FASHION FLASH LTD (Extension)

149, Shah Kabir Mazar Road, Azampur, Uttara, Dhaka
(23.867832N, 90.412555E)
4 September 2023

Observation

Lack of stability of roof truss

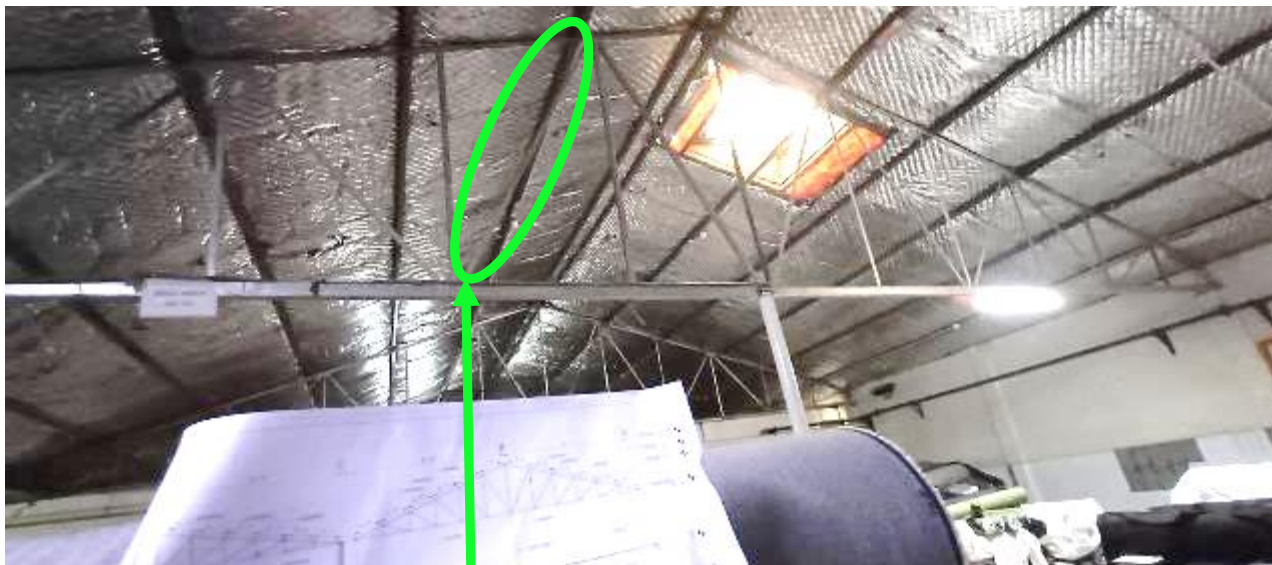
Absence of load transfer media (strut) and load resisting (bracing) system

No horizontal bracing and compression strut was found in the roof which indicates the lack of lateral stability of the roof trusses. Also, the truss member sizes seem to be inadequate. The building engineer is required to carry out Engineering Assessment (EA) to check the overall stability of the structure for lateral loading and suggest necessary remedial action accordingly.

Truss section in provided drawing

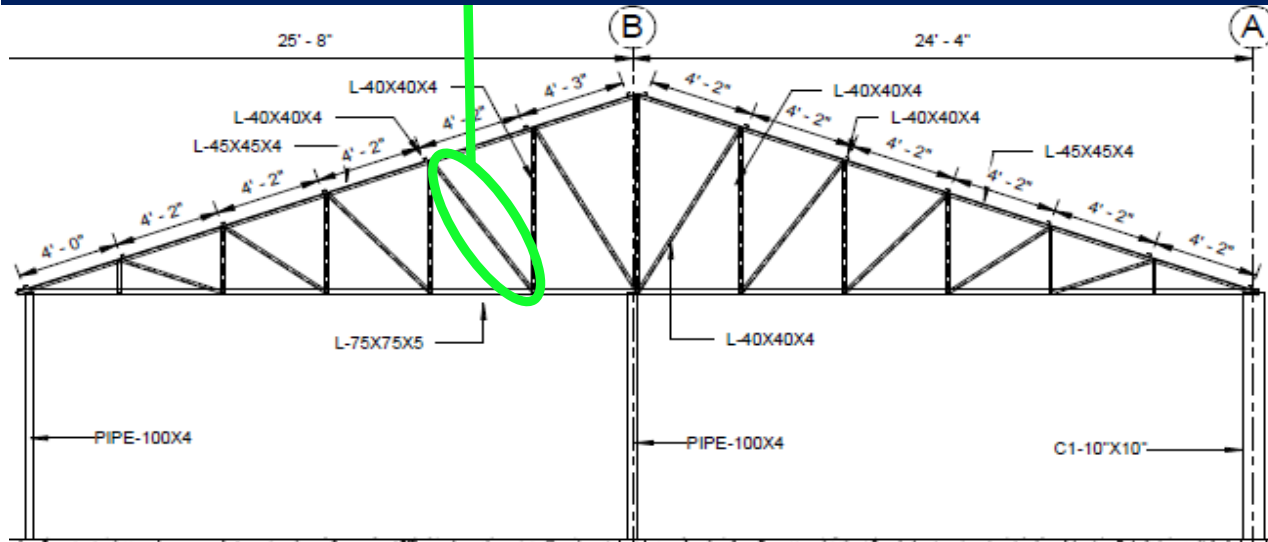
The orientation of diagonal chords not matched with provided drawing

Mismatch found in truss member arrangement. Also, connection details were missing in the provided drawing.

The building engineer is required to survey the whole structure and prepare as-built drawing as per on-site condition.
